**GENERAL INFORMATION:**

Certificate of Appropriateness for re-roofing with metal panels in "Galvalume Plus."

**STAFF RECOMMENDATION:**

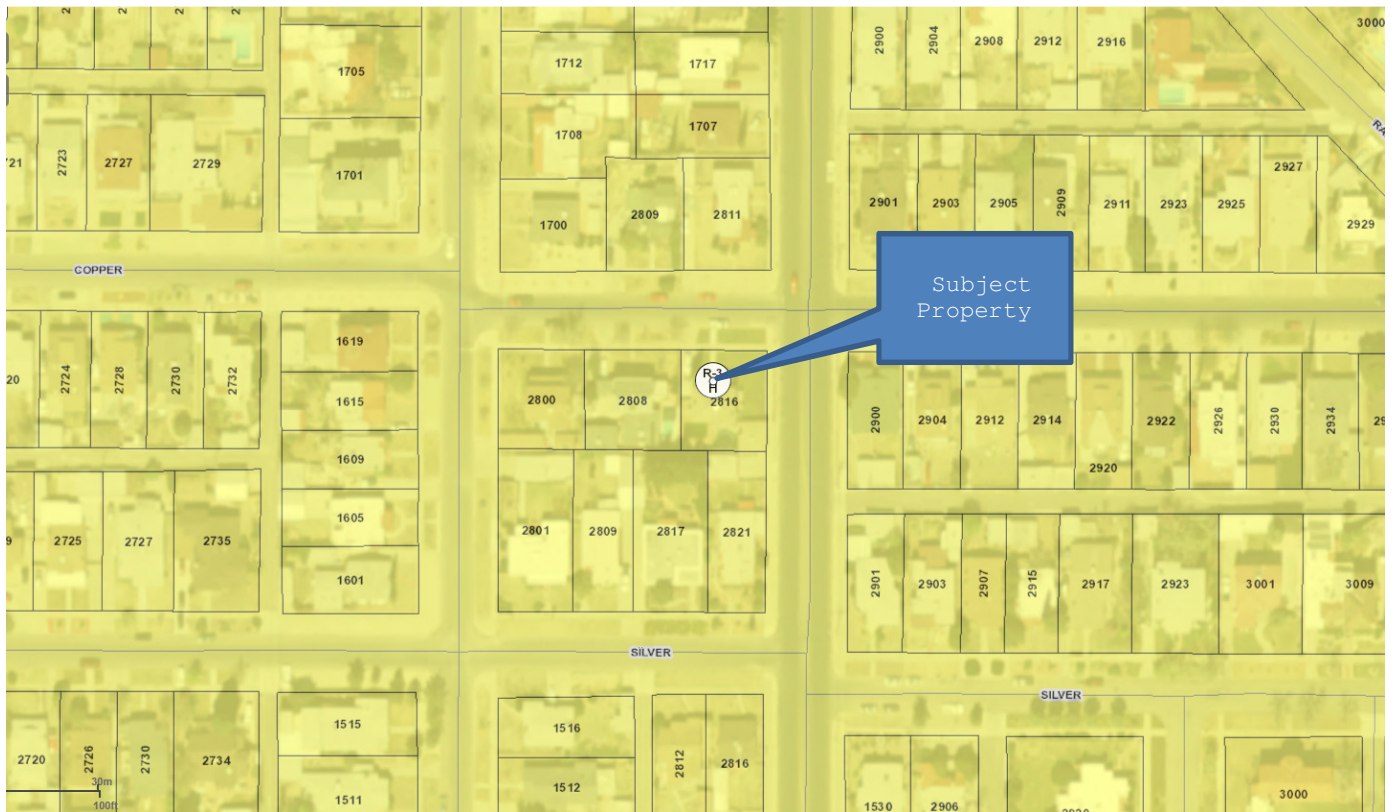
The Historic Preservation Office recommends DENIAL of the proposed scope of work based on the following recommendations:

- The distinctive features of each roof type should be retained as they are character-defining elements.
- If a roof requires repair, the replacement materials must match the original or existing materials as closely as possible. Do not change the style or construction of the roof.

- The historic character of the property will be retained and preserved.
- Exterior alterations will not destroy historic materials, features, and spatial relationships that characterize the property.
